INITIAL FIRE SAFETY INSPECTION REPORT

Unimas Sportswear (Extension 2)

RSC ID: 25870

Date: 14-Nov-2024

Table-1: Warehouse Shed-1

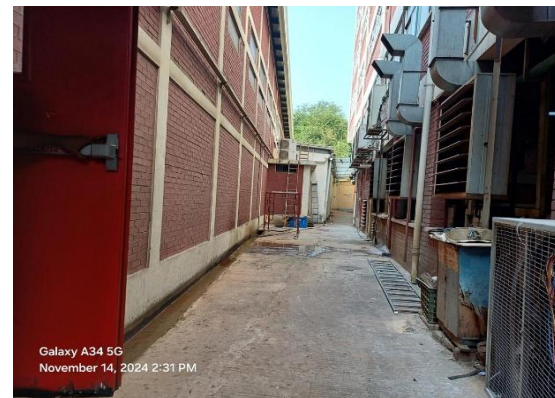
Sl No.	Category	Findings	Required Action	Remediation Time Frame
F-1	Fire Rated Construction	The Warehouse Shed-1 was constructed at 2022-23. The construction type is unprotected steel construction. Fire Resistance Ratings of Exterior Walls is not maintaining considering the Fire Separation Distance.	The construction type shall confirm to be in accordance with BNBC 2020 Part-3, Table 3.1.7. Ensure fire resistive rated construction following Table 3.3.1 (a) Part 3 Section-3, Table 3.2.2 and Table 3.2.3 Part 3 Section 2 and Table 4.1.1 from BNBC 2020 Part 4 Section 1. Provide design philosophy to determine the construction type as per BNBC 2020. If any construction rating requires, Consult a qualified fire protection engineer to achieve the require fire rating.	Within 6 months

F-2	Fire Rated Construction	Catwalk has been constructed on High rack storage and the area of the the intermediate deck creates a full floor where the size of the deck is more than 33% of the total floor area and requires fire rated separation. Location: Warehouse Shed-1	Remove the catwalk of the intermediate deck. Or , The floor must adhere to the RSC building standards and BNBC 2020 regulations regarding fire rated construction and egress features.	Within 6 Months

F-3	Fire Rated Construction	The east exit discharge path was not fire separated with New Expansion building. The egress court was not properly fire rated. The egress court has unprotected openings within 10 ft height. Location: Warehouse Shed-1	An egress court serving as a portion of the exit discharge shall be open to the sky or provided with a fire resistance rated enclosure the same as the exit enclosure. Egress courts less than 3050 mm (10 ft) in width (as measured from the building and the adjacent property line) shall be provided with walls having a 1-hr fire resistance rated construction for a distance of 3050 mm (10 ft) above the floor of the court.	Within 3 months
-----	-------------------------	--	---	-----------------

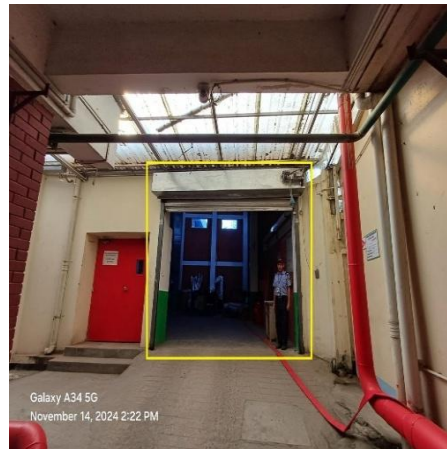
F-4	Emergency Lighting	Based on the number and location of emergency lights observed, adequate illumination levels are not anticipated along egress routes. Location: Warehouse Shed-1	Test the emergency lighting system on each floor and provide additional emergency fixtures to supply adequate illumination along the means of egress. Provide a minimum illumination of 10 lux at the floor level within exit stairs and along exit discharge paths and a minimum 2.5 lux along exit access aisles.	Within 1 Month

F-5	Means of Egress	Directional exit sign was not provided along a path of egress. Location: Warehouse Shed-1	Provide exit signs above all building exits to the exterior, all doors to the exit stairs and along all paths of travel where a change of direction is not obvious. Lighted exit signs shall be provided with either battery backup or uninterruptable power supply systems and shall be continuously illuminated.	Within 1 month

F-6	Emergency Lighting	Exit signage was not illuminated. Location: Warehouse Shed-1	Regularly inspect all exit signage and replace/install lights as needed to illuminate signs.	Within 1 month

F-7	Means of Egress	West side exit discharge path was uneven. Locations: Warehouse Shed-1.	Remove unnecessary items and level exit path to the public way.	Within 1 month

F-8	Means of Egress	Shutter type door is provided at east exit. Location: Warehouse Shed-1	Replace the shutter gate along the means of egress with side-hinged, swinging egress doors in accordance with RSC standard 6.8.1.	Within 1 month.

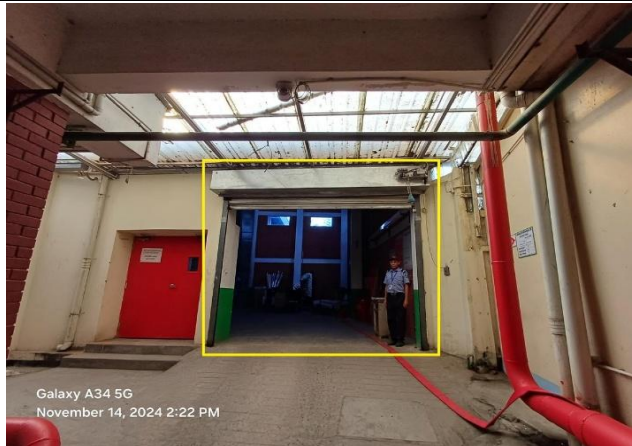
Sl No.	Category	Findings	Required Action	Remediation Time Frame
F-1	Fire Rated Construction	The Warehouse Shed-2 was constructed at 2023-24. The construction type is unprotected steel construction. Fire Resistance Ratings of Exterior Walls is not maintaining considering the Fire Separation Distance.	The construction type shall confirm to be in accordance with BNBC 2020 Part-3, Table 3.1.7. Ensure fire resistive rated construction following Table 3.3.1 (a) Part 3 Section-3, Table 3.2.2 and Table 3.2.3 Part 3 Section 2 and Table 4.1.1 from BNBC 2020 Part 4 Section 1. Provide design philosophy to determine the construction type as per BNBC 2020. If any construction rating requires, Consult a qualified fire protection engineer to achieve the require fire rating.	Within 6 months

F-2	Fire Rated Construction	The north exit discharge path was not fire separated with Dining & store shed. The egress court was not properly fire rated. The egress court has unprotected openings within 10 ft height were available with Dining & store shed.	An egress court serving as a portion of the exit discharge shall be open to the sky or provided with a fire resistance rated enclosure the same as the exit enclosure. Egress courts less than 3050 mm (10 ft) in width (as measured from the building and the adjacent property line) shall be provided with walls having a 1-hr fire resistance rated construction for a distance of 3050 mm (10 ft) above the floor of the court.	Within 3 months
 Galaxy A34 5G November 14, 2024 3:37 PM

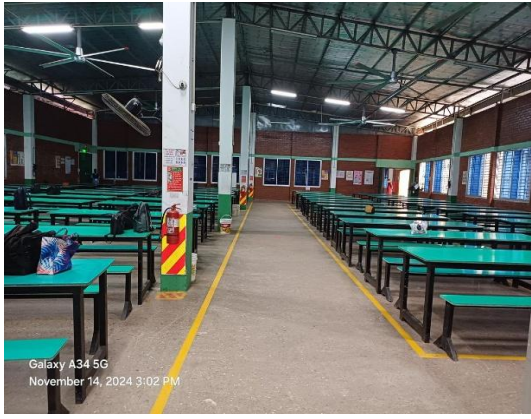
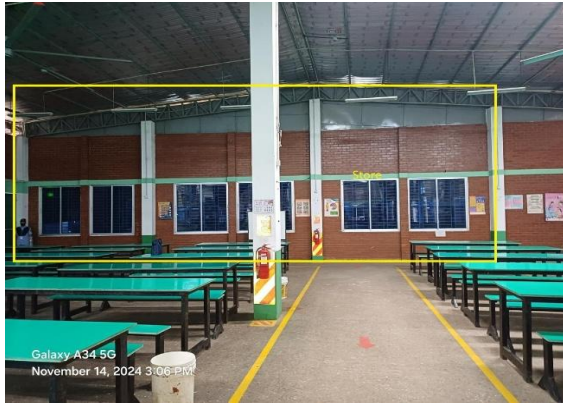
F-3	Means of Egress	West side exit discharge path was uneven. Locations: Warehouse Shed-2.	Remove unnecessary items and level exit path to the public way.	Within 1 month

F-4	Means of Egress	Aisle marking is not provided. Location: Warehouse Shed-2.	Provide minimum aisle widths of 36-inch. All the aisles shall be marked properly and free from any kind of obstruction.	Within 1 Month

F-5	Emergency Lighting	Based on the number and location of emergency lights observed, adequate illumination levels are not anticipated along egress routes. Location: Warehouse Shed-2.	Test the emergency lighting system on each floor and provide additional emergency fixtures to supply adequate illumination along the means of egress. Provide a minimum illumination of 10 lux at the floor level within exit stairs and along exit discharge paths and a minimum 2.5 lux along exit access aisles.	Within 1 Month
-----	--------------------	---	--	----------------

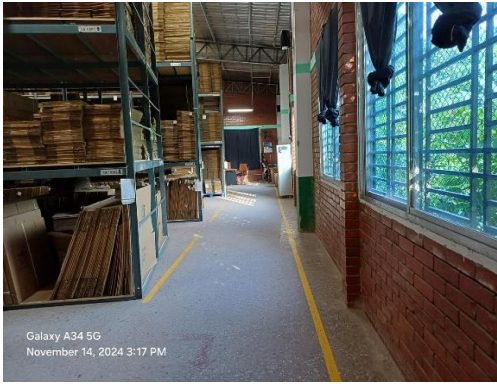
F-6	Emergency Lighting	Exit signage was not illuminated. Location: Warehouse Shed-2	Regularly inspect all exit signage and replace/install lights as needed to illuminate signs.	Within 1 month
-----	--------------------	--	--	----------------

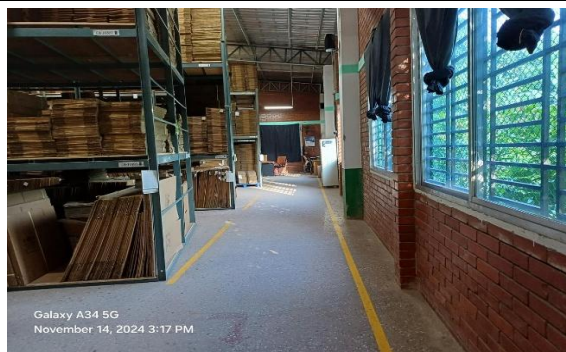
Sl No.	Category	Findings	Required Action	Remediation Time Frame
F-1	Fire Rated Construction	The Dining & Store Shed was constructed at 2022. The construction type is unprotected steel construction. Fire Resistance Ratings of Exterior Walls is not maintaining considering the Fire Separation Distance.	The construction type shall confirm to be in accordance with BNBC 2020 Part-3, Table 3.1.7. Ensure fire resistive rated construction following Table 3.3.1 (a) Part 3 Section-3, Table 3.2.2 and Table 3.2.3 Part 3 Section 2 and Table 4.1.1 from BNBC 2020 Part 4 Section 1. Provide design philosophy to determine the construction type as per BNBC 2020. If any construction rating requires, Consult a qualified fire protection engineer to achieve the require fire rating.	Within 6 months

F-2	Fire Rated Construction	Liquefied or compressed gas cylinders were located within the factory (kitchen & kitchen store) without adequate fire separation. Location: Dining & Store Shed	Remove the liquefied or compressed flammable gas cylinders. The storage or use of liquefied or compressed flammable gas (LPG/CNG) cylinders within the factory building as per section 3.4.2.1.11 of RSC Technical Guidelines (Standard)¹ V1.0. Or, Factory shall follow the requirements RSC Published "SUPPLEMENTARY PAPER ON TECHNICAL GUIDANCE NOTE FOR USE OF LIQUIFIED OR COMPRESSED FLAMMABLE GAS IN FACTORY PREMISES" to use or store liquefied or compressed flammable gas cylinders in the factory premises.	Within 3 Months

F-3	Fire Rated Construction	Dining area (I3) was not separated by fire rated construction with adjacent store room (H2). Location: Dining & Store Shed	The dining area (I3) is not permitted with storage area (H2) following table 3.2.1 of BNBC-2020. Required number of exits for entire dining arrangement shall lead directly to safe discharge path without passing through another occupancies.	Within 3 months

F-4	Emergency Lighting	Based on the number and location of emergency lights observed, adequate illumination levels are not anticipated along egress routes and at exit stairs on all floors. Location: Dining & Store Shed	Test the emergency lighting system on each floor and provide additional emergency fixtures to supply adequate illumination along the means of egress. Provide a minimum illumination of 10 lux at the floor level within exit stairs and along exit discharge paths and a minimum 2.5 lux along exit access aisles.	Within 1 Month

F-5	Emergency Lighting	Directional exit sign was not provided along a path of egress. Location: Dining & Store Shed	Provide exit signs above all building exits to the exterior, all doors to the exit stairs and along all paths of travel where a change of direction is not obvious. Lighted exit signs shall be provided with either battery backup or uninterruptable power supply systems and shall be continuously illuminated.	Within 1 month
